**SITE PLAN REVIEW COMMITTEE  
MEETING AGENDA**

**Item 1. SP #435 2025 Clarendon Boulevard (Wendy's/Wells Fargo) 7:00–8:25 p.m.**  
(RPC# 17-011-011, -012)

### **AGENDA: First Meeting—July 28, 2014**

Deviations from Site-Specific Guidance (pp.26-27):

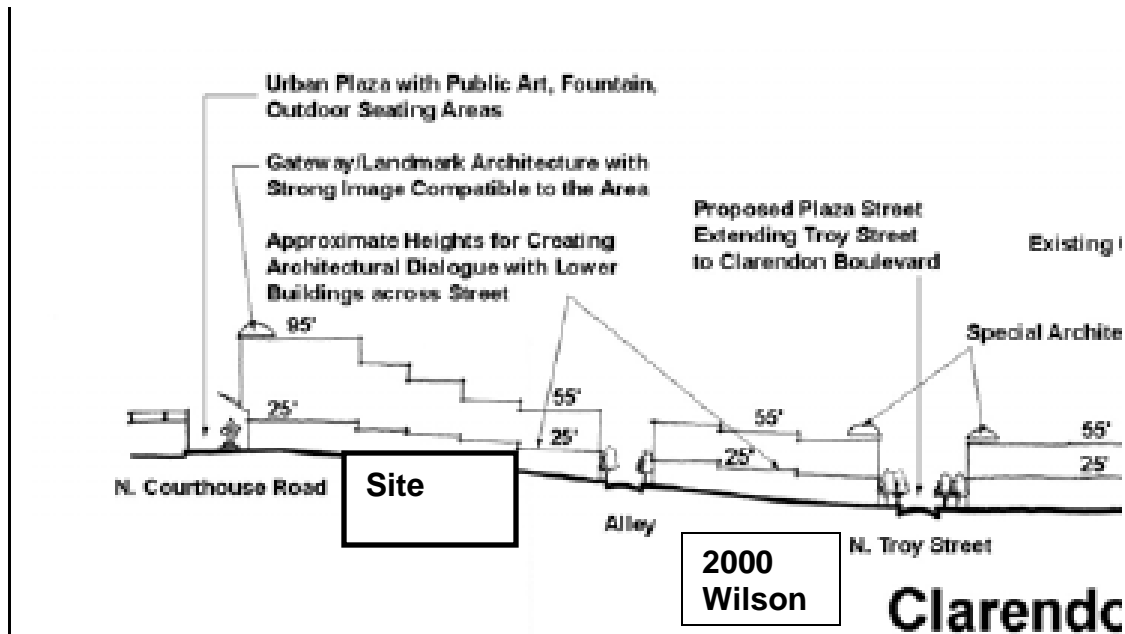
- *"Buildings no higher than 10 stories generally, except vertical architectural elements at the western end."*
  - The proposed building is 12 stories. However, the *Study* also states that "Flexibility in heights could be approved to accommodate affordable housing, community facilities, special design considerations and or/new streets (p. 19)."
- *"Horizontal treatment at the top of the second floor is encouraged to relate to historic buildings across Wilson Boulevard."*
  - While not in the "site specific guidance", the *Study* additionally recommends a step back of at least 20 feet on the second level. Instead, the proposed building actually widens by 6.5 feet above the second story.

The *Study* also has additional height and taper guidance for this site on pages 13 and 14, and recommends a taper from "9 stories to 5 stories" (at the eastern property boundary) and 95 feet to 55 feet as seen in the below exhibit. Staff acknowledges that there is a discrepancy between the below exhibit (which recommends a maximum of 9 stories) and the site-specific guidance excerpted above, which recommends a maximum height of 10 stories for this site.
